Subject: **Docket No. 50-361**  
**Response to Request for Additional Information (RAIs 2, 3, and 4)**  
**Regarding Confirmatory Action Letter Response**  
**(TAC No. ME 9727)**  
**San Onofre Nuclear Generating Station, Unit 2**

SOUTHERN CALIFORNIA EDISON  
RESPONSE TO REQUEST FOR ADDITIONAL INFORMATION  
REGARDING RESPONSE TO CONFIRMATORY ACTION LETTER

**Response to RAIs 2, 3, and 4**

Figure 1 – Model for Estimating TTW Initiation Time

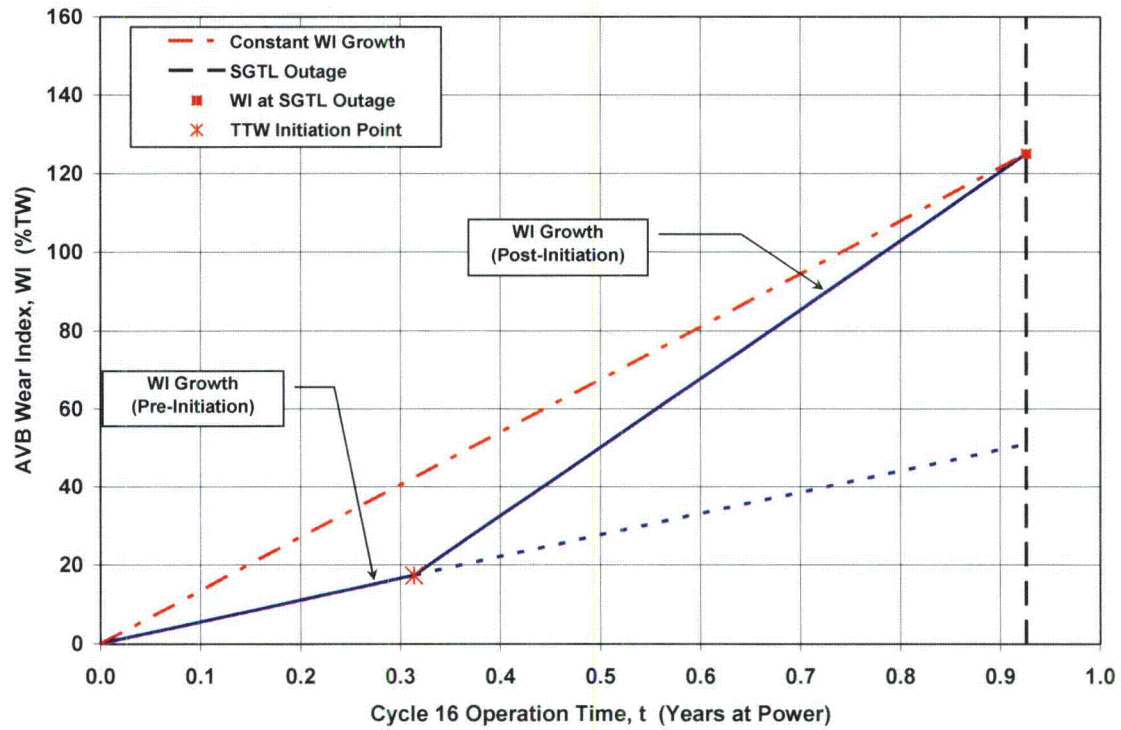
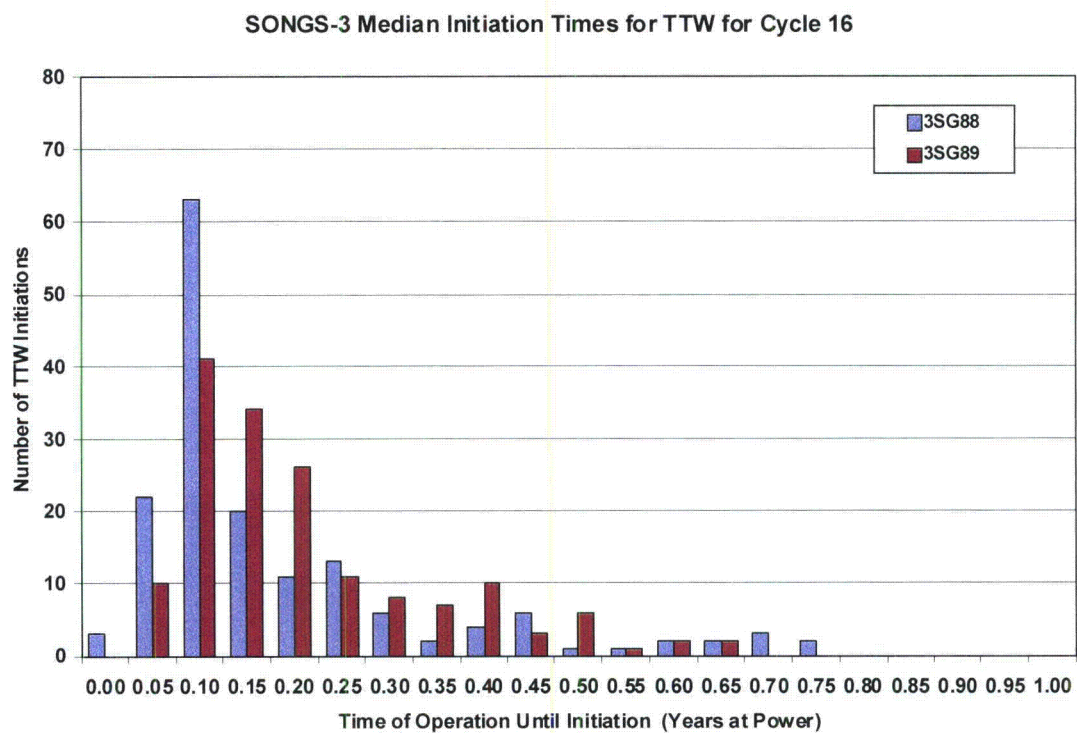
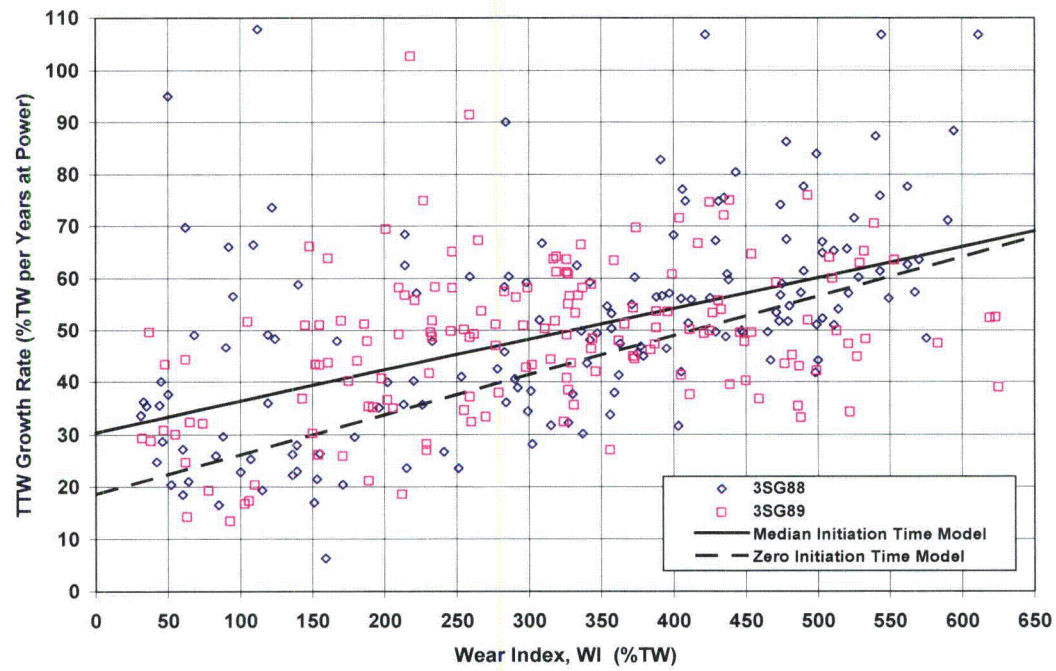
The Operational Assessment in Attachment 6, Appendix C (Reference 4), pages 3-2 and 4-12, appears to state that tube-to-tube wear (TTW) growth rates are based on the maximum TTW depths observed in Unit 3 at EOC 16 divided by the first Unit 3 operating period (0.926 years at power). Provide justification for the conservatism of this assumption. This justification should address the following:

- a. Reference 4, page 3-2 defines “wear index” for a degraded tube and states that the existence of TTW and distribution of TTW depths are strongly correlated to the wear index. This is pictured in Figures 4-4 in terms of TTW initiation. This figure shows that TTW is not expected to have initiated until a threshold value of wear index is reached. This threshold value varies from tube to tube according to a cumulative probability distribution shown in the figure. This figure illustrates that TTW is not expected to have initiated until sometime after BOC 16. This suggests that the observed TTW depth at EOC 16 developed over a smaller time interval than the 0.926 years assumed in the analysis.

To address the RAI question of TTW initiation time and the impact on the allowable inspection interval for Unit 2, additional analysis was performed. A time dependent predictive model (initiation-time model) for estimating the operating period prior to TTW initiation in Unit 3 was developed. This model is illustrated in Figure 1. This figure is a schematic example for a single tube where the rate of increase in the wear index is allowed to vary.

As shown in Figure 1, the growth in the wear index occurs in two stages: pre-initiation and post initiation. The initiation-time model for TTW uses a wear index based only on tube to AVB wear in the upper supports (B03 through B10). This model's wear index (WI) starts to increase at the beginning of the cycle. The basis for this approach was developed from the Unit 3 wear data as follows:

The predicted TTW initiation time is calculated by simulating two-stage growth in the WI. The initiation model is constrained to the end state for the calculated wear index from the NDE results. The slopes for the growth in the WI are also constrained to keep the two-stage process bounded by the constant WI growth case illustrated in Figure 1.

**Figure 4 – WI Comparison between Bobbin-Based and +Point™-Based Models**

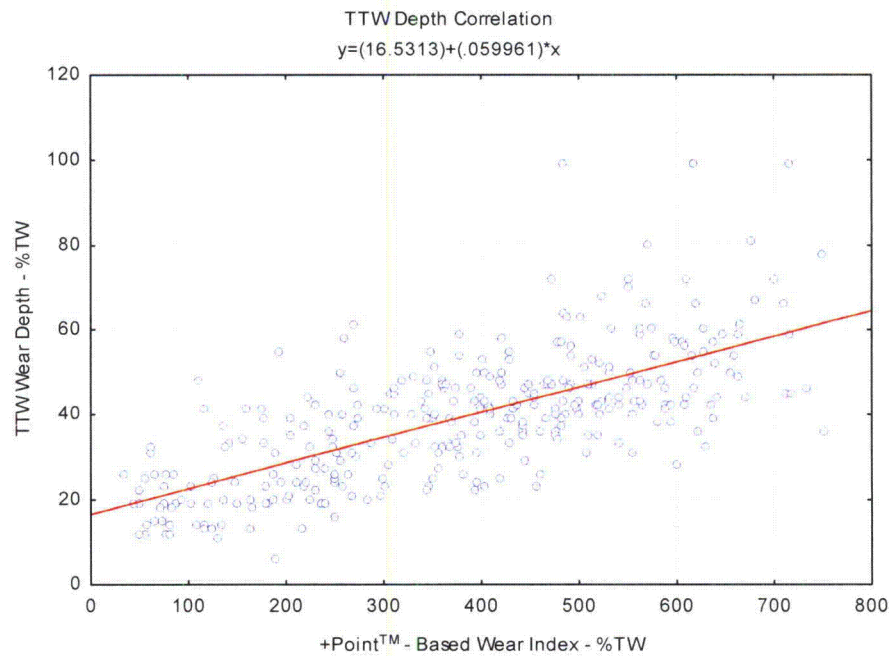
Regarding Reference 4, does the definition of “wear index” include summing the depths of 2-sided wear flaws at a given AVB intersection? If not, explain why SCE’s approach is conservative.

The WI for Unit 2 tubes was further evaluated against the TTW depth correlation using the two WI models. Figure 4 shows the values for bobbin WI and +Point™ WI plotted for each tube with detected support wear in the high wear region. The dominant wear is due to tube-AVB contact. The +Point™ WI is higher than the bobbin WI. There is an approximate 35% average increase in the WI for the +Point™ WI.
